U.S. NUCLEAR REGULATORY COMMISSION  
REGION I

Report No. 50-272/87-35; 50-311/87-35

Facility Name: Salem Nuclear Generating Station-Units 1 & 2

Inspection Conducted: November 30, 1987 - December 4, 1987

PUBLIC SERVICE ELECTRIC AND GAS COMPANY  
 SALEM NUCLEAR GENERATING STATION  
 125 V. D. C. ONE LINE  
 Unit 1

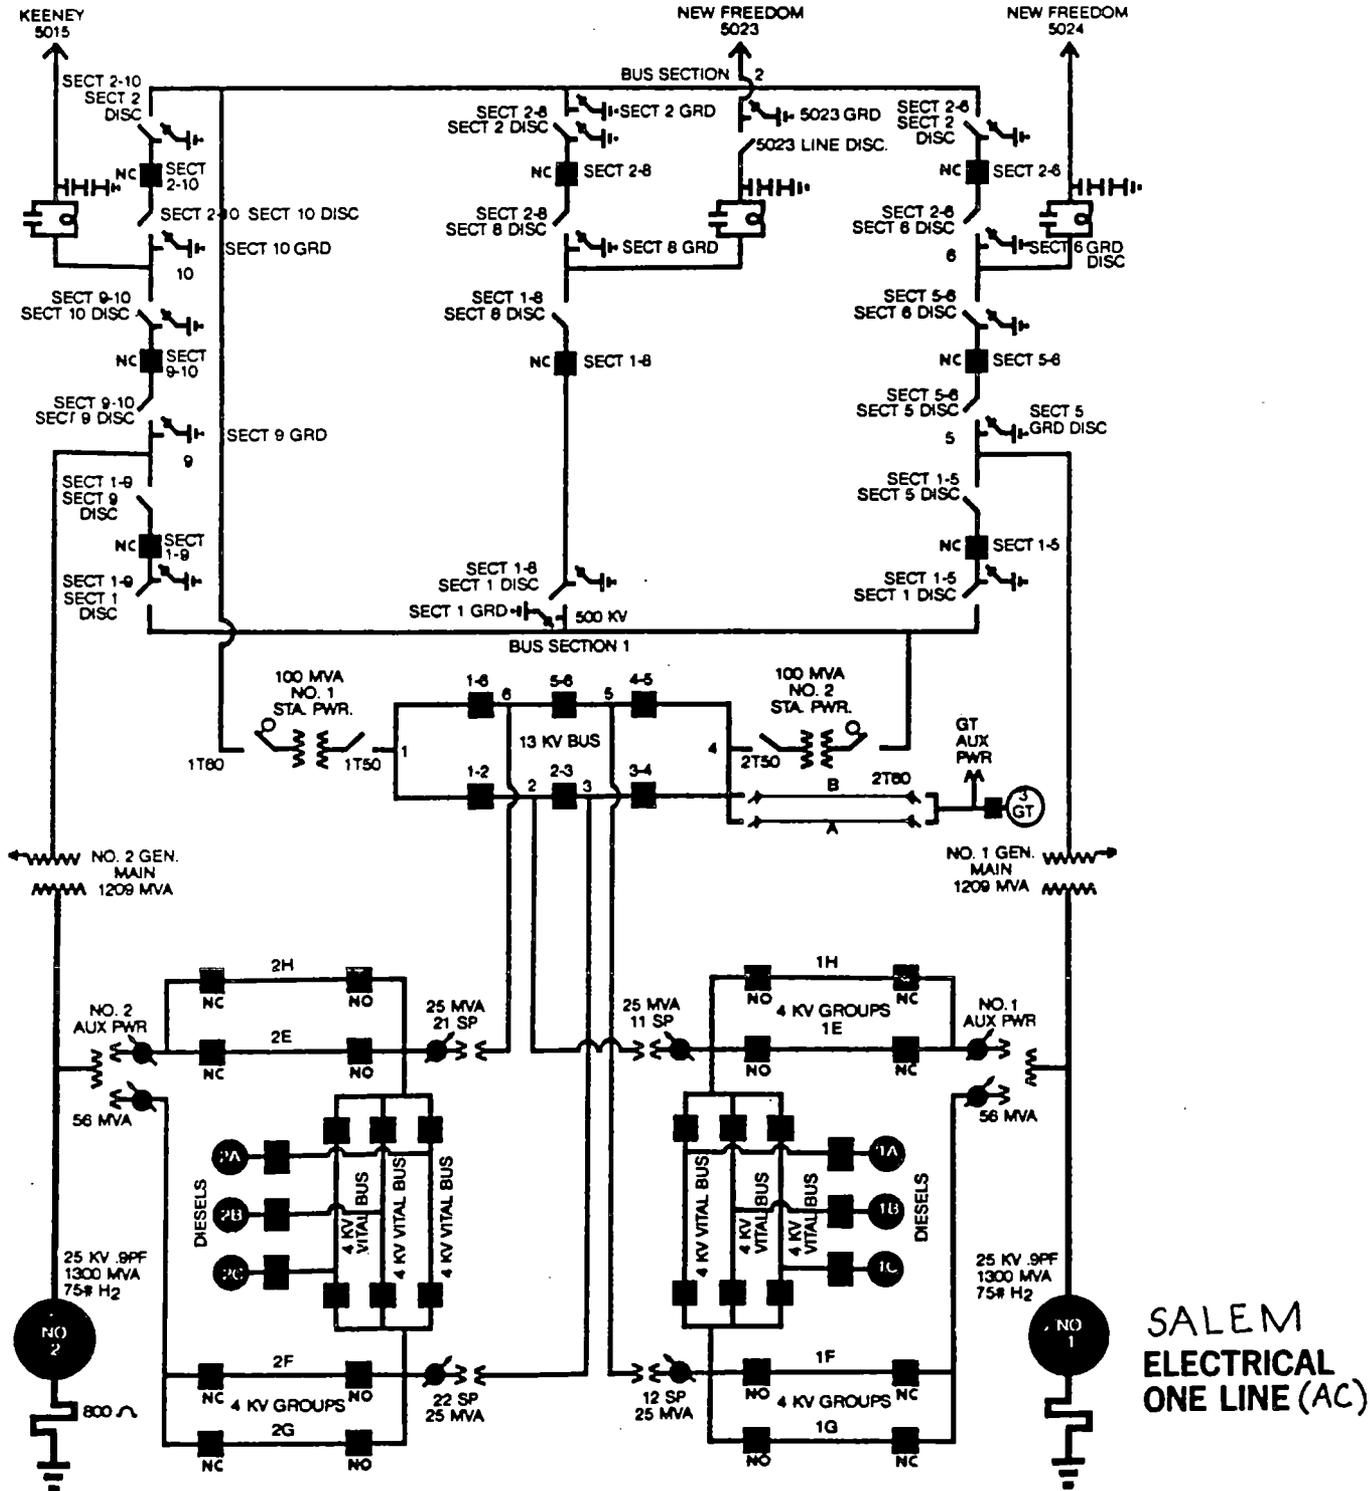
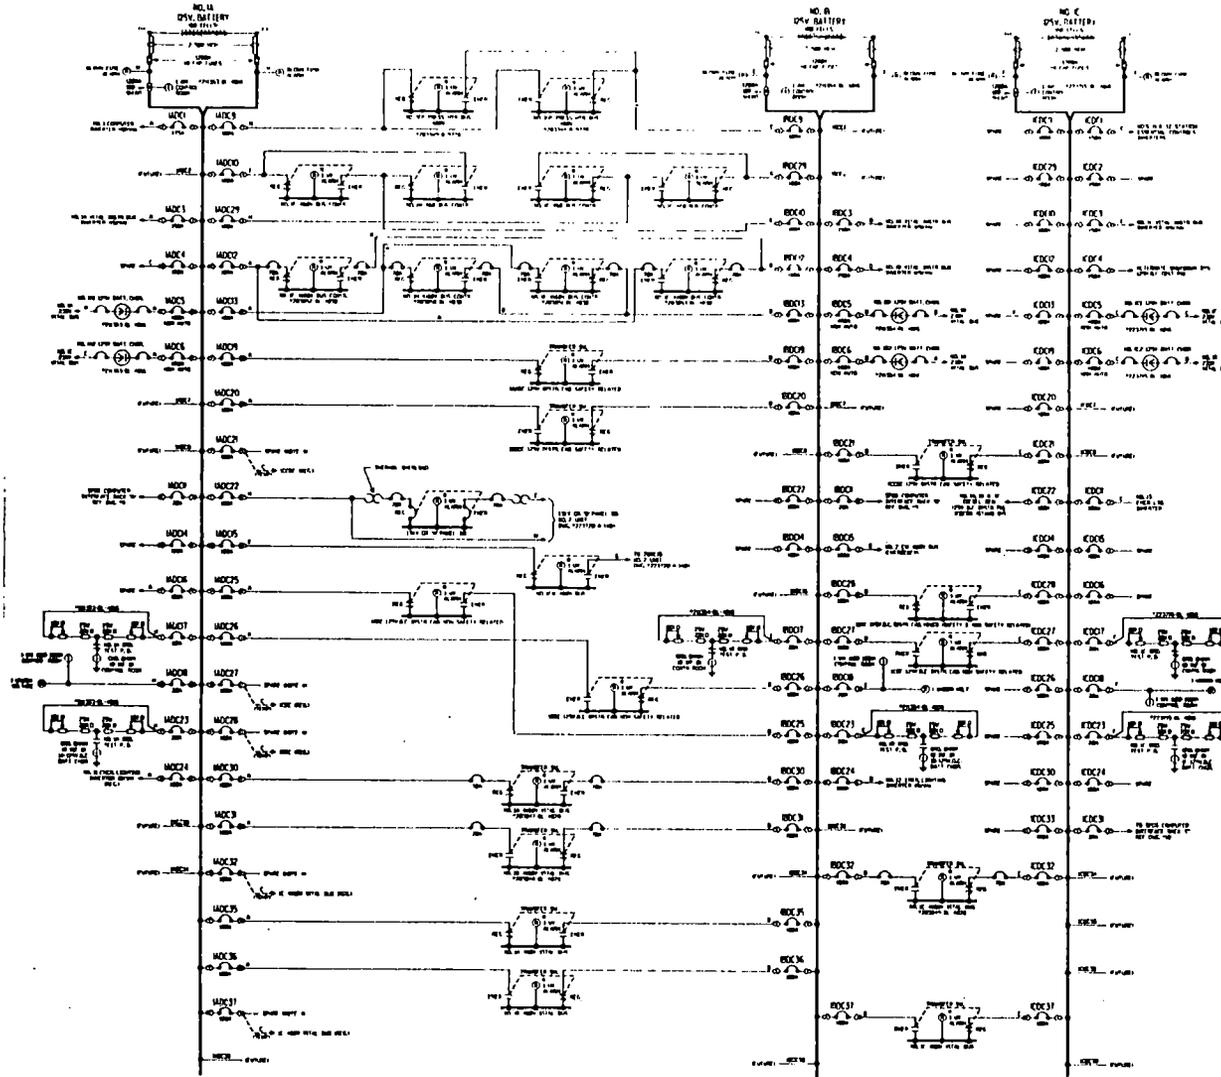
During review of the Unit 1 125 VDC one line electrical diagram (DWG. 203007) the inspector questioned whether the battery charger output circuit breaker has been reviewed with respect to coordination with the main battery fuses such that a fault within the charger would not result in a blown fuse and result in the loss of the entire DC bus. The licensee determined that coordination for these breakers had not been reviewed and subsequently found that similar to the inverter feeds, full coordination was not present. The inspector verified the physical configuration of the battery chargers with respect to the DC bus to confirm the licensee's determination that there is no common cause which would lead to the simultaneous loss of more than one DC bus due to the absence of total coordination. The licensee included these cases in the SER.
